HISTORIC LANDMARK COMMISSION JANUARY 27, 2020 APPLICATION FOR A HISTORIC SIGN PERMIT C14H-1990-0013 422 GUADALUPE STREET REPUBLIC SQUARE

Install two flush-mounted signs.

Building seen from the south, looking across Republic Square.

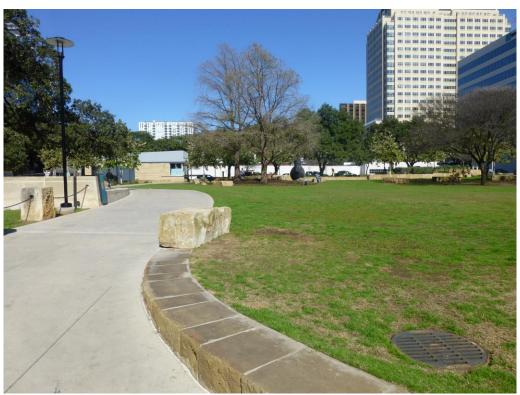
The proposed sign on the south elevation is 29 square feet, while the proposed sign on the east elevation is 37 square feet. Neither meets this standard. However, staff feels that the larger signs may be appropriate given their orientation to the large open spaces in Republic Square and the Federal Courthouse plaza.

The ampersand on both signs is proposed to be neon. The Commission may consider this proposal as a limited element on both signs.

The building does not have a business entrance; instead, the proposed signs are located above the order windows.

Approve the proposed sign design and dimensions, and consider the exposed neon ampersands.
